**Final Environmental Impact Report  
Alessandro Business Center**

State Clearinghouse #: 2007021005

# Contents

M1-8

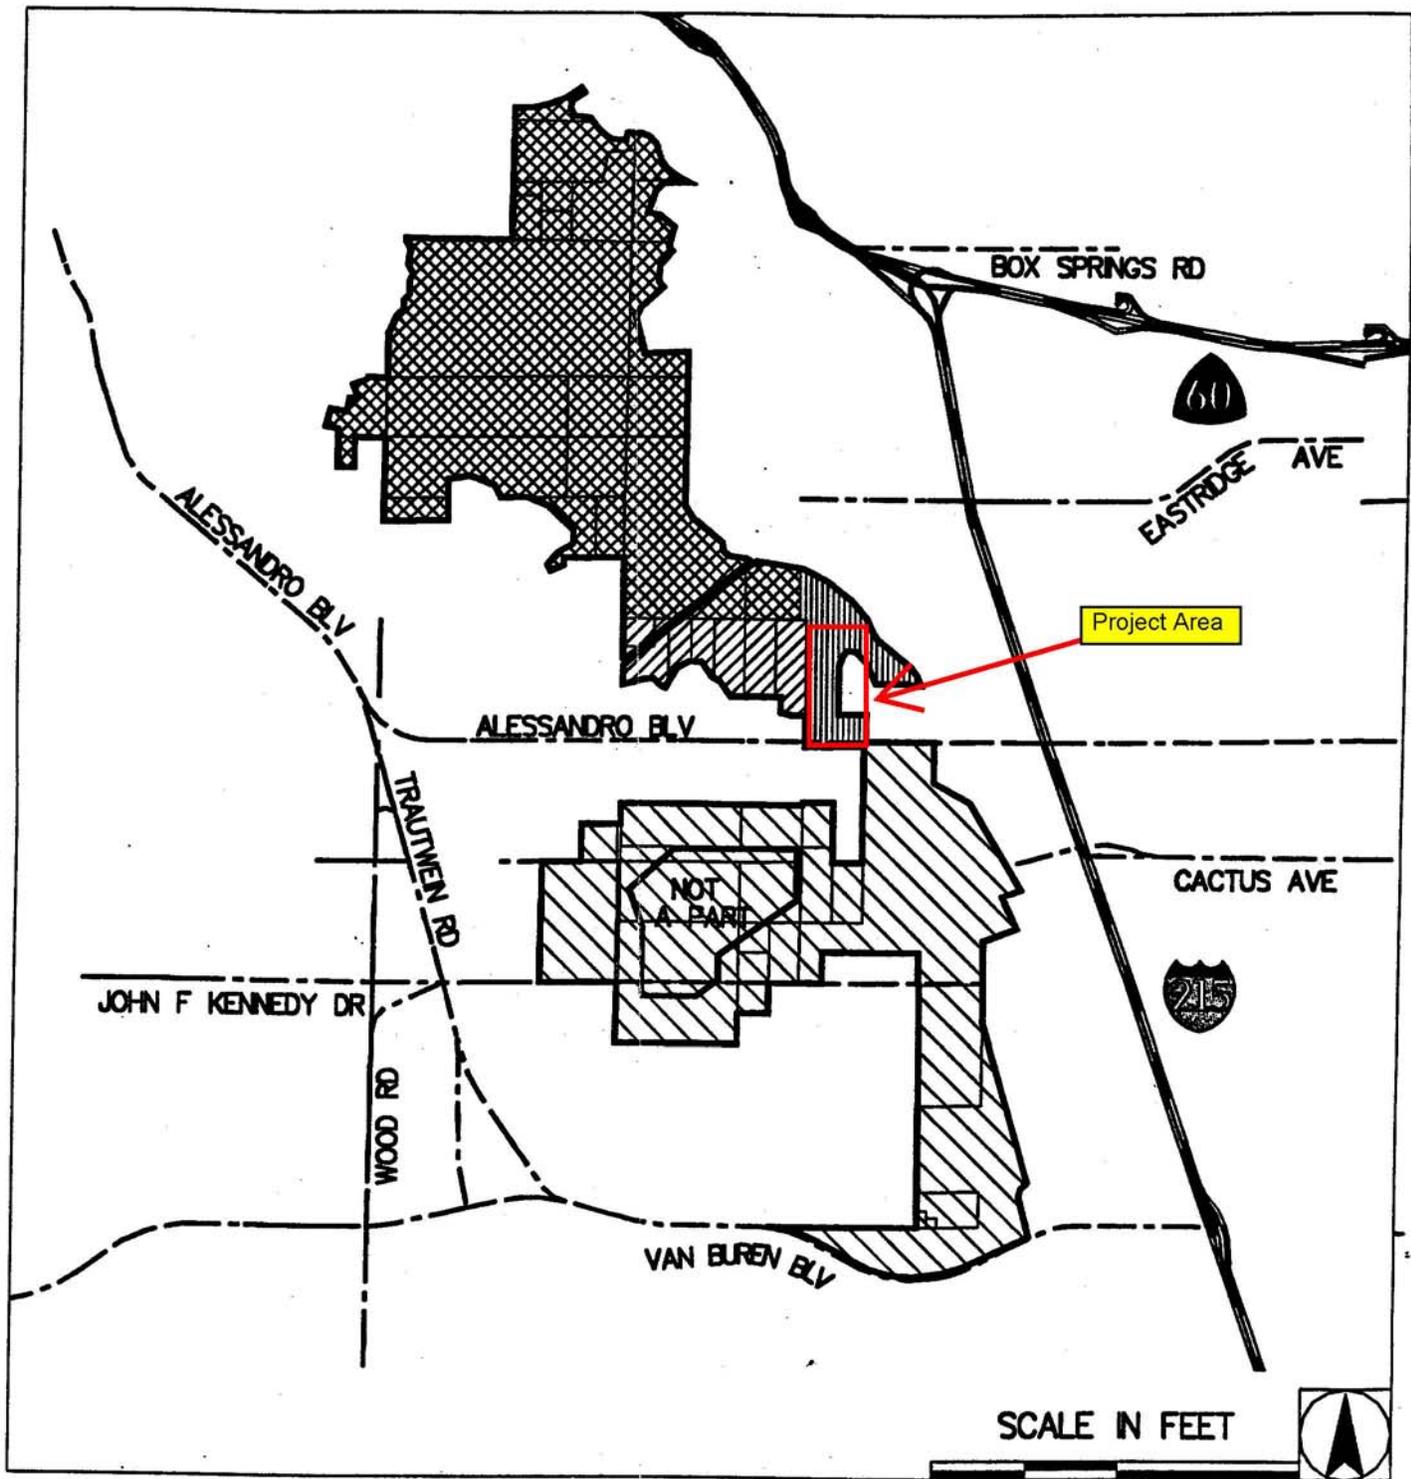
Finally, I should add for the record that I have expertise in the area of conservation biology, ecology, and genetics. I am a Professor of Biology at the University of California Riverside (UCR), a member of the steering committee of UCR's Center for Conservation Biology, and I was a member of the MSHCP Scientific Advisory Committee established during the development of the MSHCP. Part of my research program is focused on conservation genetics and the effects of habitat fragmentation, including work on the conservation genetics of SKR (having published scientifically on the subject, a work cited in the species description of SKR in the MSHCP document).
